Enclosure 3
March 2009 Meeting Handouts
Meeting Summary of the 03/19/09 Reactor Oversight
Process Working Group Public Meeting
Dated April 10, 2009

Industry Proposed Resolution of PMT – Available/Operable Issue

NRC MSPI White Paper

Figure 1: Available / Not Operable

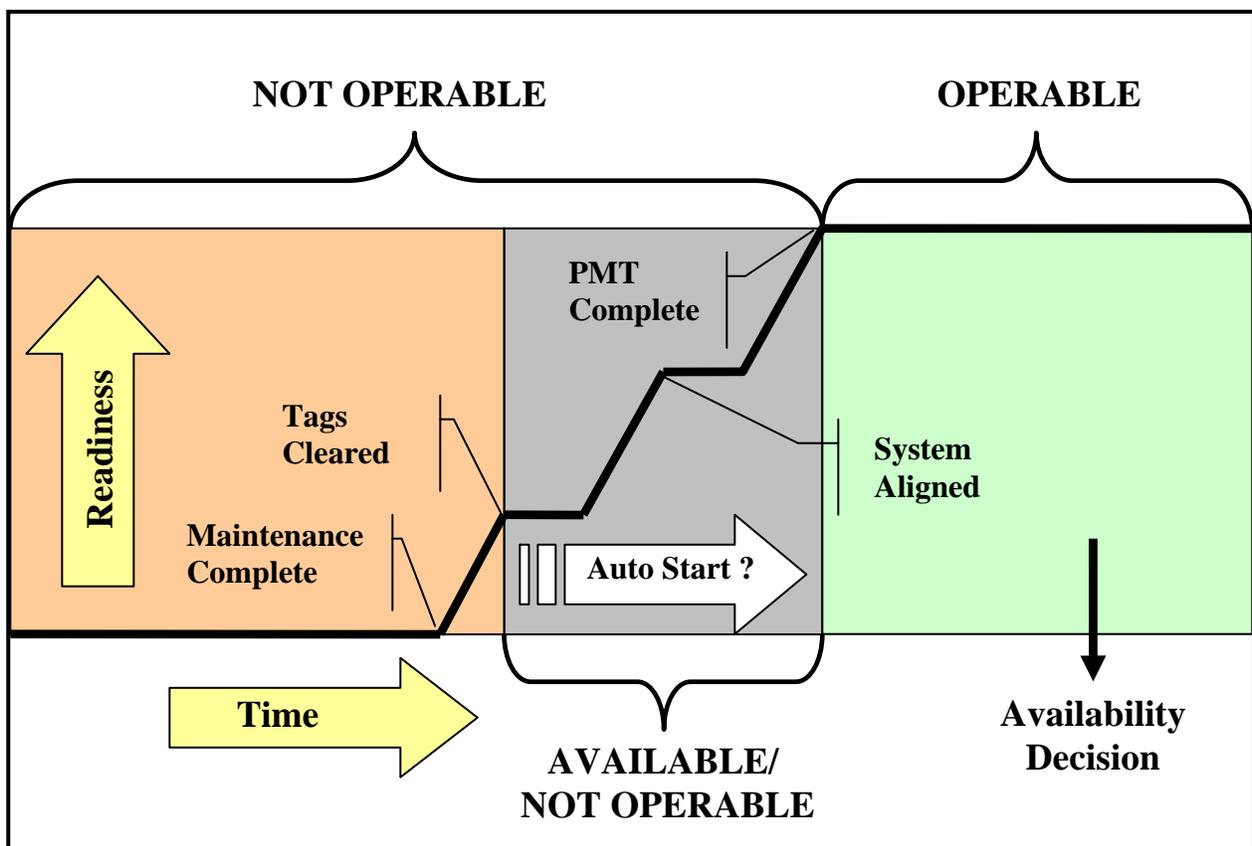
The staff's concern with this approach is:

- Lack of clear guidance
- Potential for limited operator awareness
- Potential for non-conservative treatment of equipment reliability
- Potential for regulatory inconsistency

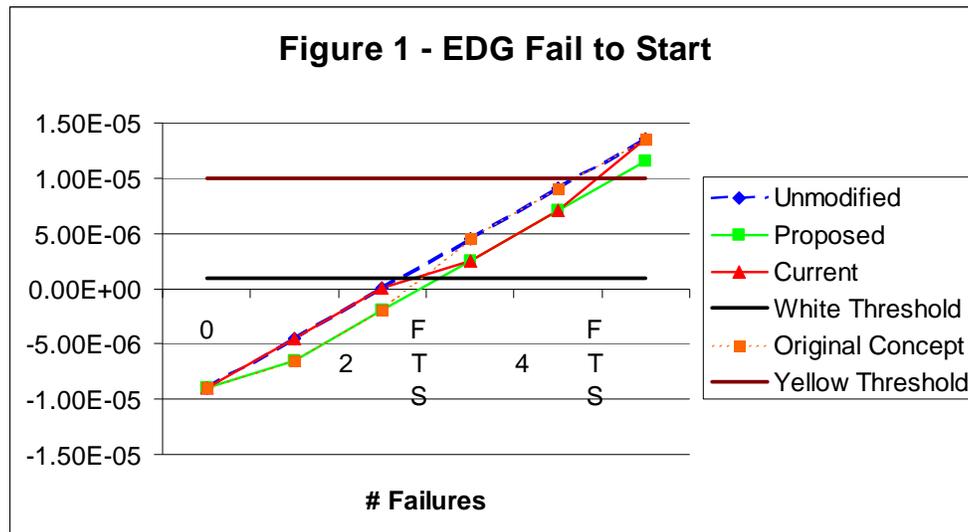
Figure 1 shows the impact of each additional EDG failure to start. It should be noted that both the current and proposed risk cap treatment results in the same MSPI color regardless of the number of failures.

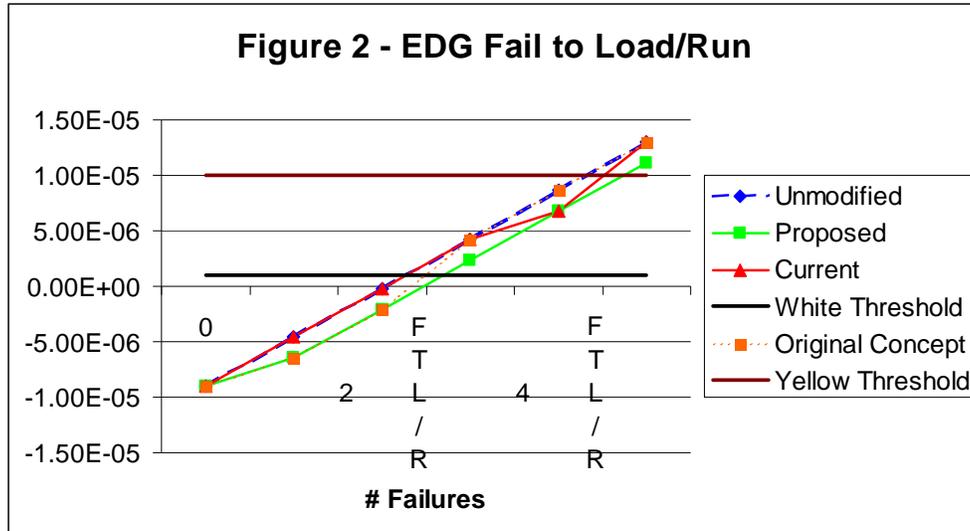
Figure2 shows the impact of each additional EDG failure to load/run. As with failures to start, both the current and proposed risk cap treatment results in the same MSPI color regardless of the number of failures.

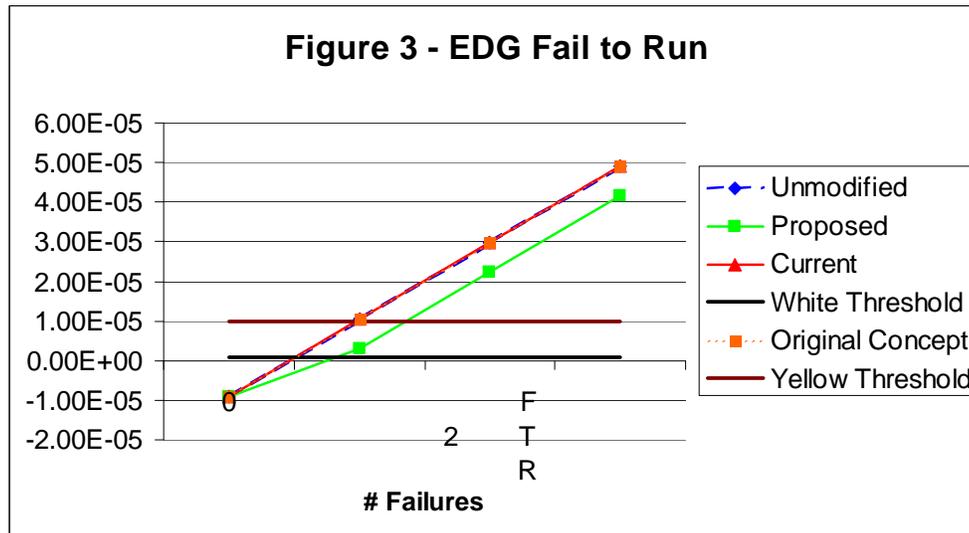
Figure 3 shows the impact of each additional EDG failure to run. The primary difference between the current Risk Cap and the proposed Risk Cap is that under the current risk cap, a single failure (with the included contribution from unavailability) results in a Yellow MSPI, while under the proposed change to the Risk Cap, this results in a White Configuration. A second failure results in a Yellow MSPI from both approaches.

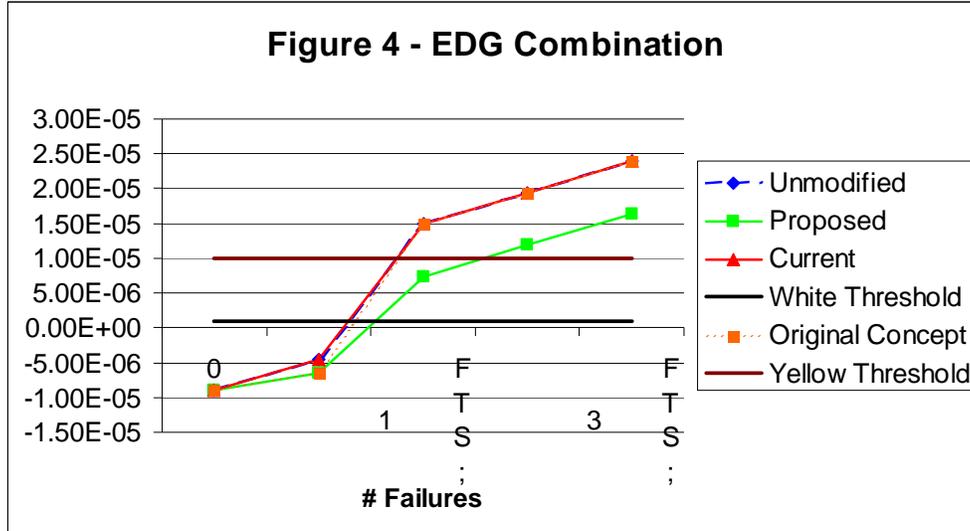
Figure 4 shows the impact of from different failure modes. The first failure is assumed to be a failure to start, followed by a failure to run then additional failures to start. Under the current Risk Cap treatment, the MSPI jumps from Green to Yellow following the failure to run, even though neither failure may be statistically significant. The proposed Risk Cap change results in a smoother transition (Green, White, Yellow) as additional failures are added.

Example 2: NUREG-1816, Case 1

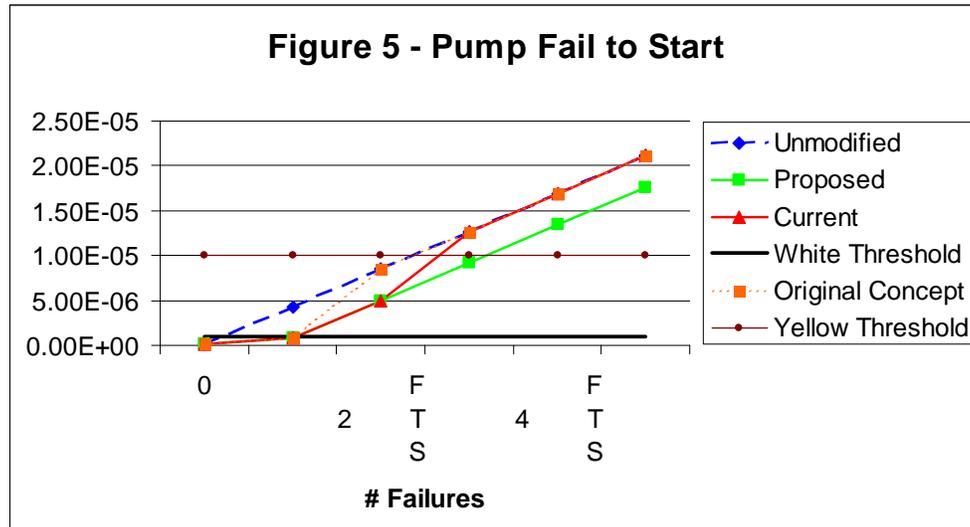
For this example, a plant experiences a start failure of an Auxiliary Feedwater motor-driven pump. Prior to the failure, the $UAI = 1 \times 10^{-7}$. The delta URI associated with the start failure is 4×10^{-6} . No other failures have occurred during this reporting period yielding an URI baseline of zero (this is a simplification since baseline could be below zero). The UAI contribution resulting from the repair unavailability is 2×10^{-7} . For this scenario, both the current Risk Cap and proposed change result in exceeding the White Threshold after the 2nd failure. However, it does require 1 additional failure (4 failures versus 3 failures) to exceed the Yellow threshold under the proposed change to the Cap (See Figure 5).

Example 3 – Essential Service Water Pump Failure to Run

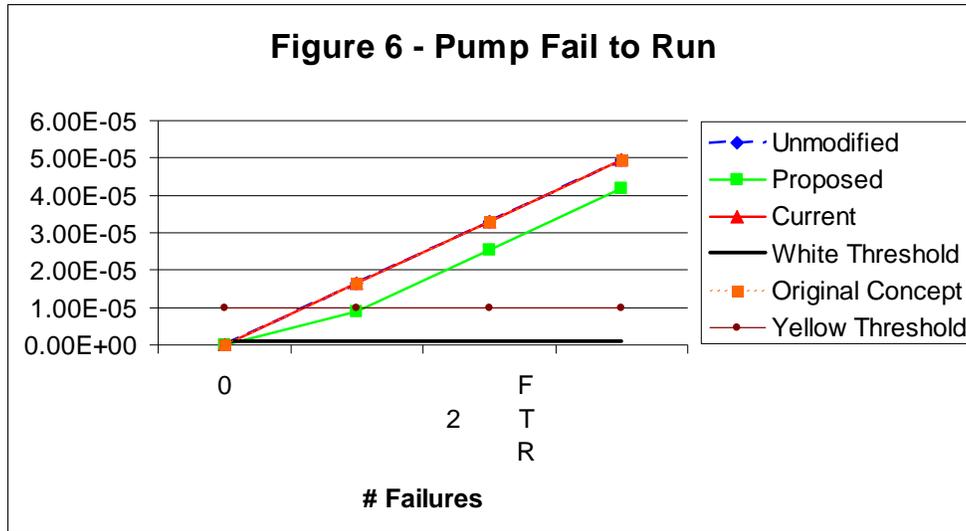
A plant has a URI with no failures of -4.50×10^{-6} . The MSPI value is -4.2×10^{-6} with a UAI of 2.7×10^{-7} . (Note that there are 2 pump failures in the other CWS, each with a URI

For this plant, a single failure to run results in a Yellow MSPI under the current Risk Cap. With the proposed Risk Cap, the MSPI is White following a single Failure to Run and Yellow after the second failure (See Figure 6).

Example 4 – Increasing UA

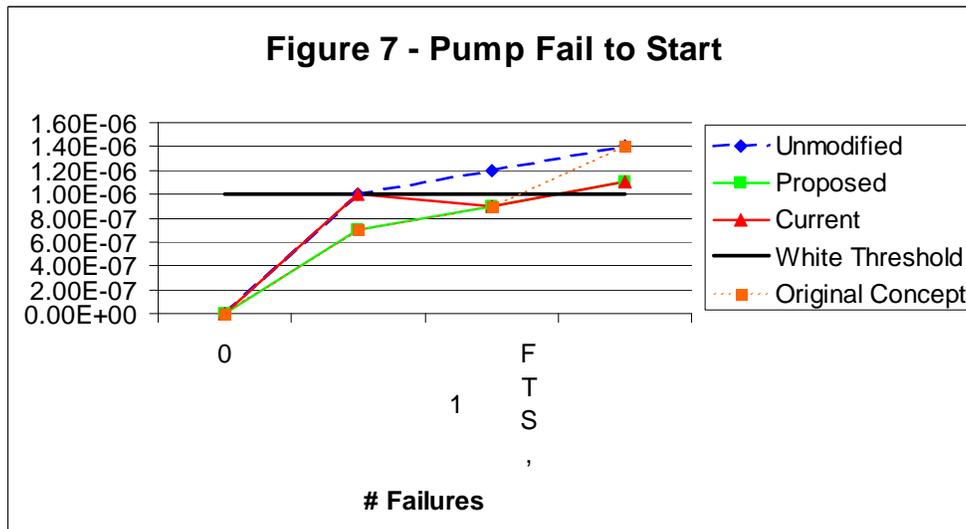
For this example, it is assumed that the MSPI is at 0 and that a Failure to Start has a URI contribution of $8E-7$. Following the first failure, the UA contribution is increase in $2E-7$ increments. As can be seen in Figure 7, since the current Risk Cap is only applied once the MSPI exceeds $1E-6$, increases in UAI can result in a decrease to the MSPI value. The revised Risk Cap eliminates this discrepancy.
